# The Light company

South Texas Project Electric Generating Station  
Units 1 and 2  
Docket Nos. STN 50-498 and 50-499  
Proposed Amendment to the Unit 1 and Unit 2  
Technical Specifications to Replace  
Spray Additive with Recirculation Fluid pH Control

SIGNIFICANT HAZARDS EVALUATION FOR THE  
REPLACEMENT OF THE SPRAY ADDITIVE SYSTEM  
WITH THE RECIRCULATION FLUID pH CONTROL SYSTEM

Figure 1.2-12 Revision 0

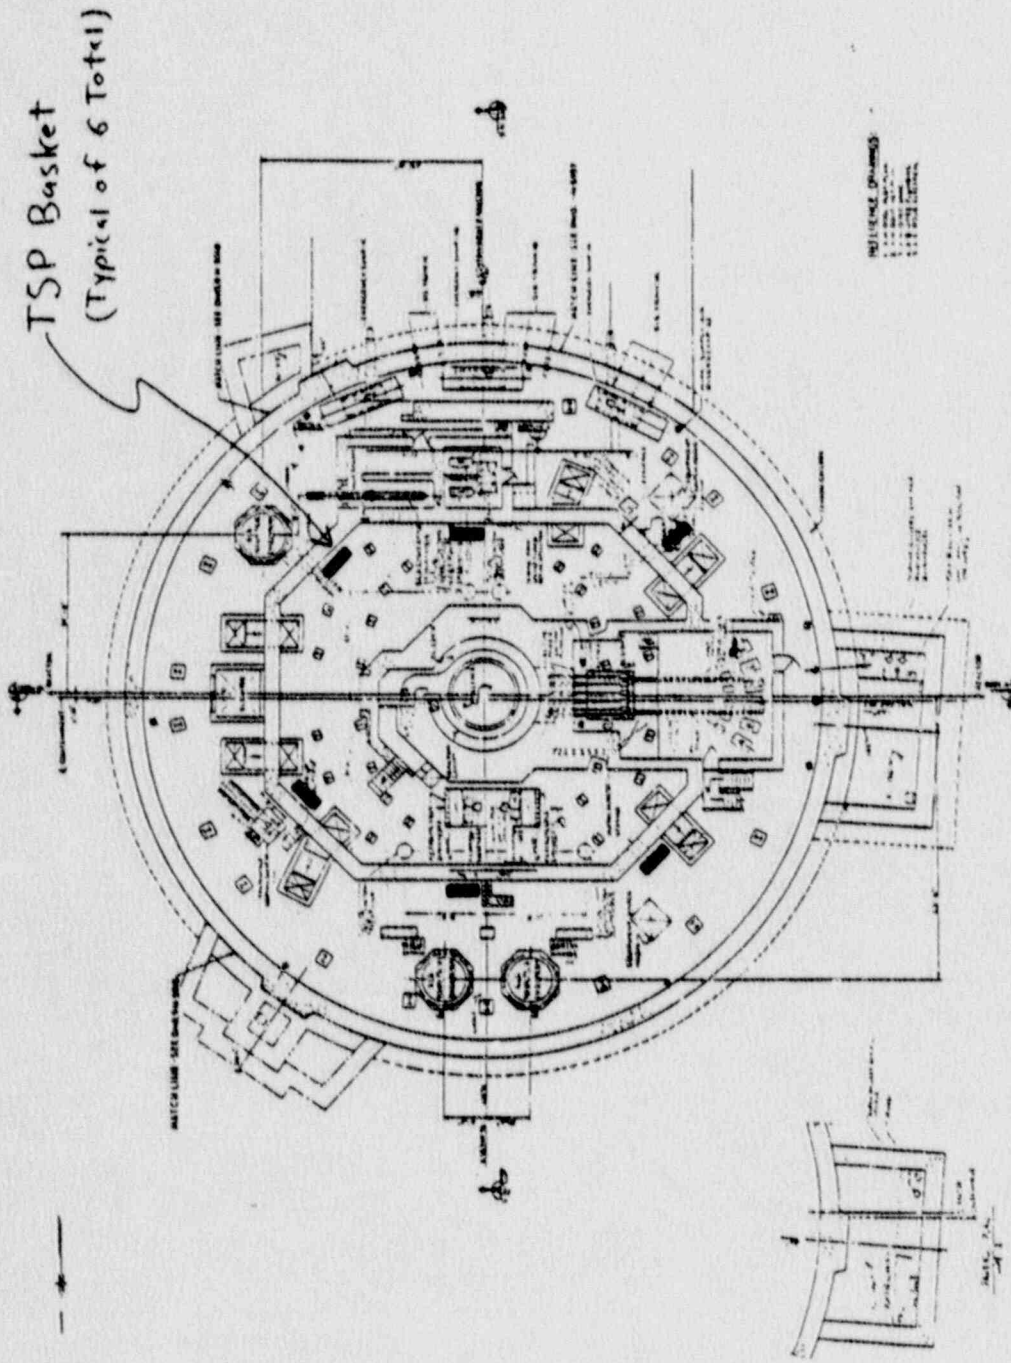
The proposed replacement for the liquid sodium hydroxide spray additive system consists of solid trisodium phosphate (TSP) stored in baskets strategically located in the post-LOCA flooded region of the containment (Figure 1.2-12). Additional detail is included in the attached WCAP-12477.

P&ID  
 CONTAINMENT SPRAY SYSTEM  
 (Sheet 1 of 2)  
 Desg. No. SN10-9-F-05037-01 Rev. 1.2  
 Figure 5.2.2-1 Revision 0

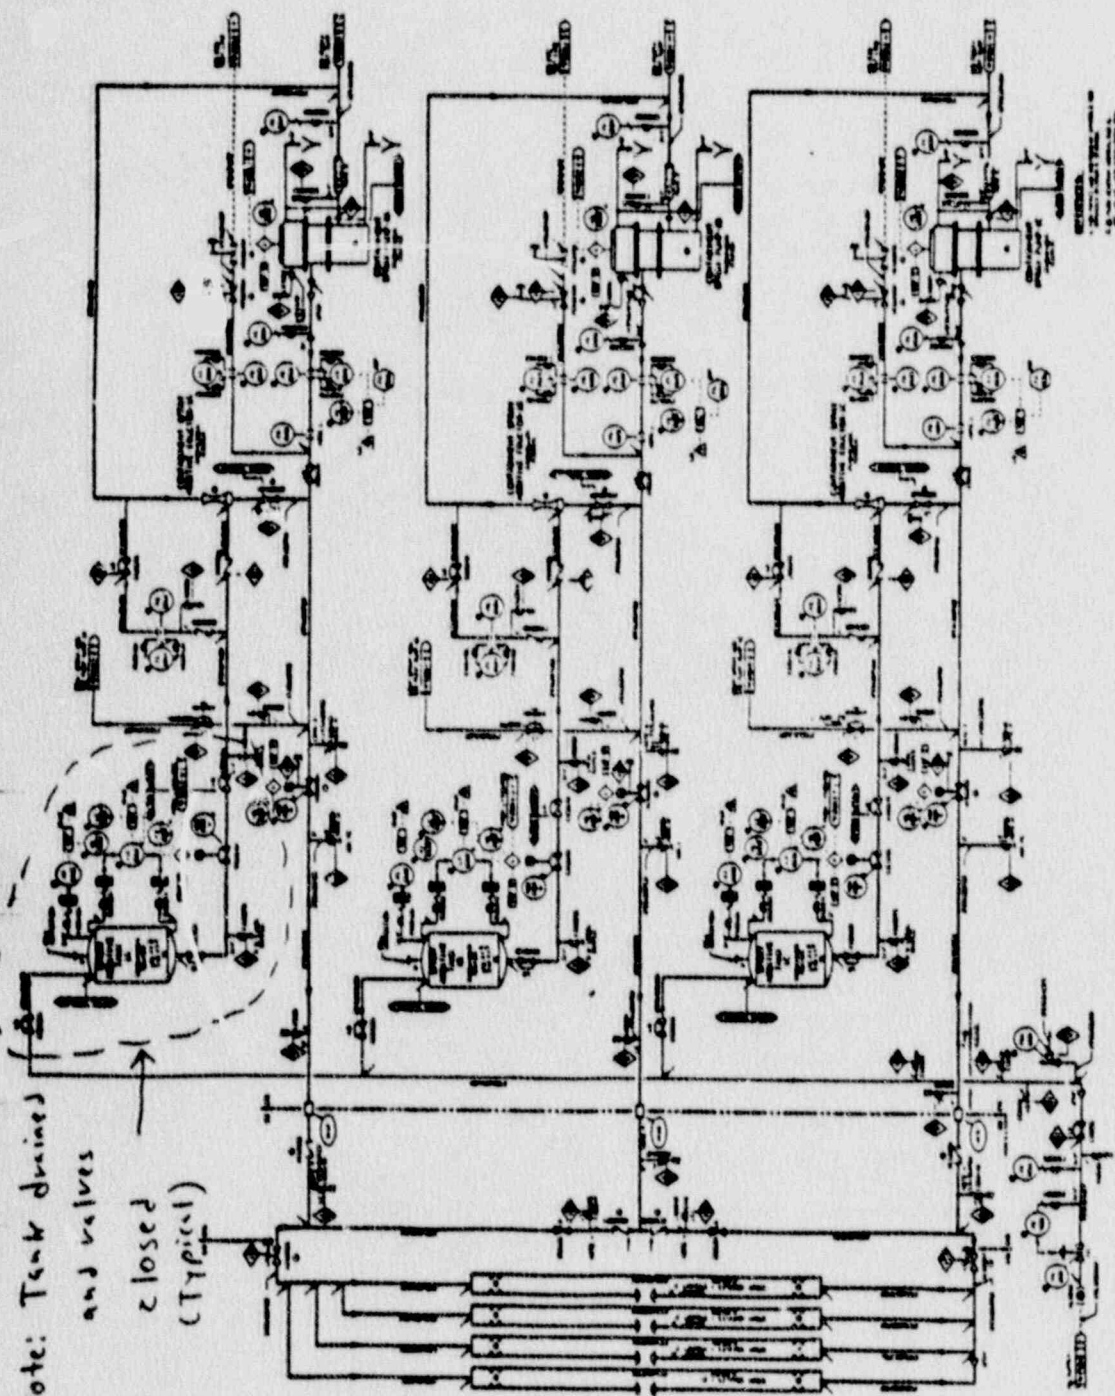
The proposed change eliminates the potential for contamination of primary grade water by sodium hydroxide leakage into the Reactor Coolant System. This leakage causes depletion of resin used to remove the contamination and can result in higher dose rates. The Spray Additive Tank will be drained and the associated valves will be closed upon implementation of the proposed change (Figure 6.2.2-1).

Note: Tank drained  
and valves  
closed  
(Typical)
